R66 SERVICE BULLETIN SB-14

DATE: 25 June 2015

SUBJECT: Tail Rotor Drive Shaft Forward Bearing

Figure 1

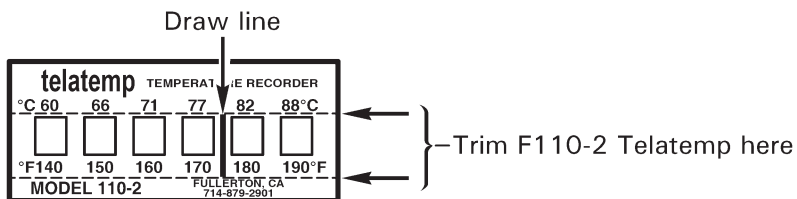
1. Refer to Figure 1. Using a black, permanent-ink marker, draw a line between the 170°F and 180°F temperature squares on a P/N F110-2 or 110-2 Telatemp. Trim Telatemp as shown; ensure the Fahrenheit temperature scale is still legible.
2. Remove tailcone cowling per R66 Maintenance Manual (MM) § 53-23.
3. Refer to Figure 2. Using a lint-free cloth dampened with acetone, clean exterior of F172-1 bearing assembly. Install trimmed Telatemp on right side of F172-1 bearing assembly as shown. Ensure squares are well bonded to the bearing housing. Allow the temperature scale to overhang the aft edge of the housing if necessary. Install tailcone cowling per MM § 53-23.
4. Insert enclosed Special Pilot Caution (page 3 of this bulletin) as the first sheet of the Pilot's Operating Handbook.

SPECIAL PILOT CAUTION

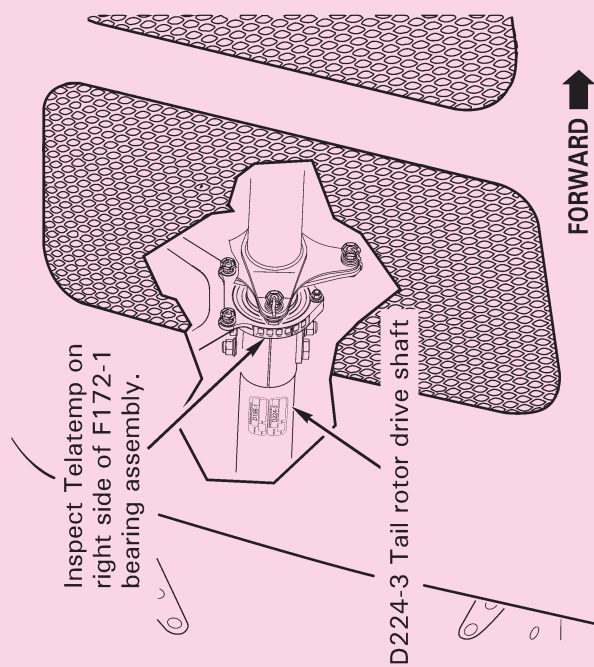
During each preflight check, inspect Telatemp on right side of F172-1 bearing assembly. If any squares have darkened beyond black line (180°F or greater), have aircraft serviced prior to further flight.
